Southampton to London Pipeline Project

Response to the Examining Authority's First Written Questions General Questions (GQ)

Application Document: 8.6.02

Planning Inspectorate Reference Number: EN070005

Figure GQ.1.17.2: Plans Showing the Existing and Proposed Pipeline Routes along with the relevant planning authority boundary

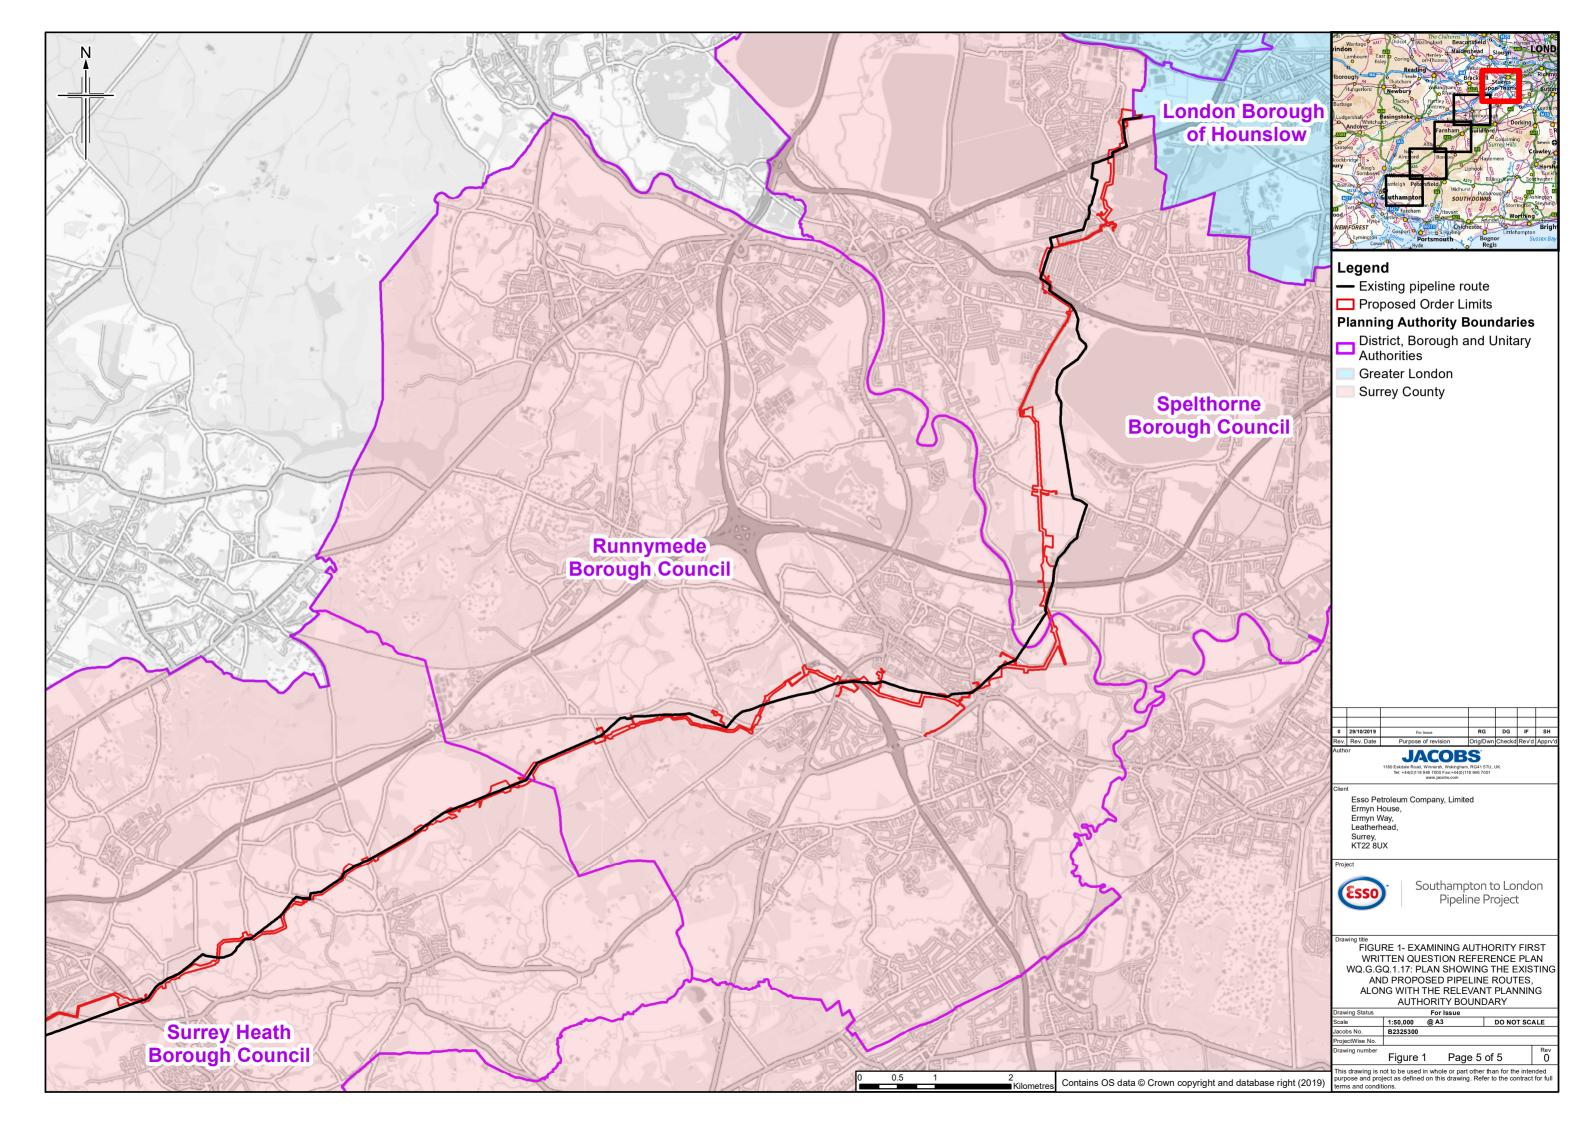
iii) Provide a plan of trenchless crossing areas; or iv) Signpost where this can be found in the	1.4 In response to iv), trenchless crossing area plans are listed in the Register of Environmental Actions and Commitments (Application Document <u>APP-056</u>) and detailed in Annex B of the CoCP (Document Reference 6.4 Appendix 16.1 (2)). Annex B of the CoCP makes clear that the relevant references are also expressed within the General Arrangement Plans <u>AS-056</u> , <u>AS-057</u> and <u>AS-058</u>).
	Application; and v) Explain how this is secured in the draft DCO [AS-059].	1.5 In response to v), compliance with the CoCP (including Annex B) is secured under Requirement 5 of the draft DCO (Document Reference 3.1 (3)).
	N.B – You may wish to combine the response to this question with GQ.1.15 above	
GQ.1.17	Provide a plan showing the existing and proposed route with the Relevant Planning Authority	1.1 A plan showing the existing and proposed route with the Relevant Planning Authority boundaries was not submitted with the Application Documents.

ExQ1	Question:	Applicant response to Question:
	boundaries or signpost where such a plan exists in the Application documents.	1.2 Therefore, plans are submitted to the Examining Authority in response to this question. The main plan (Figure GQ.1.17.1 – Key Plan) shows, at a scale of 1:250,000, the existing pipeline and the proposed Order Limits from Boorley Green to the West London Terminal storage facility, with the Relevant Planning Authority boundaries. This plan is also split into five sheets (Figure GQ.1.17.2 – Sheets 1 to 5) at a scale of 1:50,000, which also show the existing pipeline and proposed Order Limits with the Relevant Planning Authority boundaries in more detail.
GQ.1.19	Chapter 3 of the ES [APP-043] states that the above ground components are, through design and materials, resilient to climate change effects. Explain how this conclusion has been reached and which effects have been considered.	1.1 Section 3.4.1 of the Flood Risk Assessment (FRA) (Application Document <u>APP-134</u>) states that 'the replacement pipeline would be buried underground for its entire length with the exception of the pigging station and smaller elements such as valves, cabinets and marker posts. During the operational phase the buried pipeline has no effect on flood risk and only the above ground infrastructure needs to be considered'.
